Director City Planning Report No. CP70/16

Subject: CBD and South East Light Rail -
proposed modification to permit
tree works

Folder No: F2014/00453

Figure 1 – Location of the two mature trees on the corner of Alison and Darley Road shown in red.

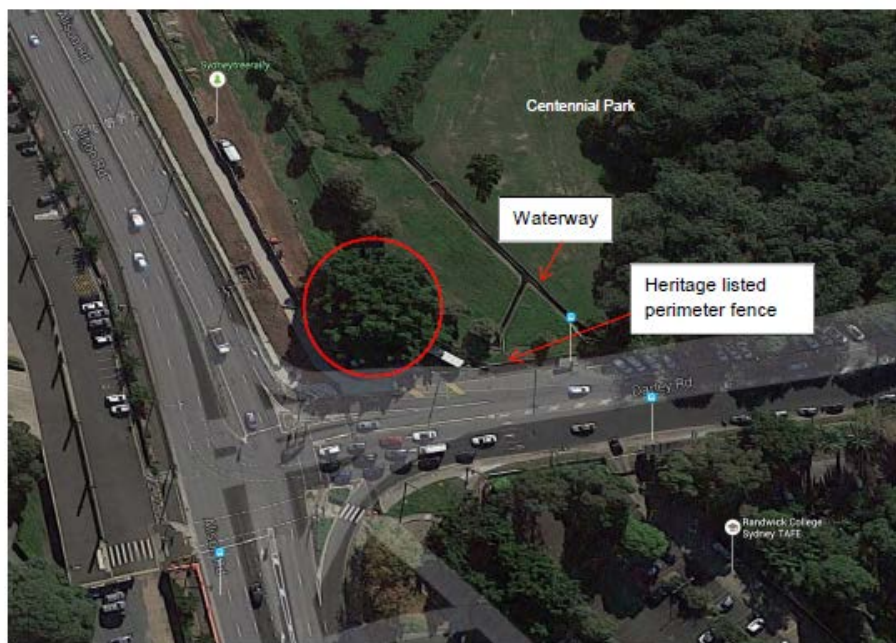
The Modification notes that the proposed tree works would require the removal of less than 10% of the crown from each tree. Minor pruning would be required in future, to maintain the clearance around the overhead wires of the light rail line. It is noted that the 3 metre clearance as stated in the report is incorrect; 2.7 metre clearance has been previously adopted for Alison Road.

Most importantly to the health of the trees is adherence to the appropriate root pruning practices in accordance with the Australian Standards, as stated in the Modification Report. Council advises that prior to any root pruning works, a hand dug trench 1.5m deep by 200mm wide be excavated along the southern side of the structural root zone (Alison Rd side) for an independent arborist to further assess impacts to tree roots.

The key concern with this proposed Modification is that it provides insufficient protection of the trees from impact beyond the 10% currently anticipated. The proposed changed wording of the Conditions of Approval does not limit the extent of tree work allowed to the trees, and creates conditions in which additional and potentially substantial tree work, or even removal, could occur without further formal approval requirements.

1. Council endorses making a submission to the Department of Planning and Environment objecting to the Proposed Modification, and;
2. Council recommends that the proposed modification be re-evaluated on the basis of a 2.7 metre clearance around the overhead wires for the light rail.
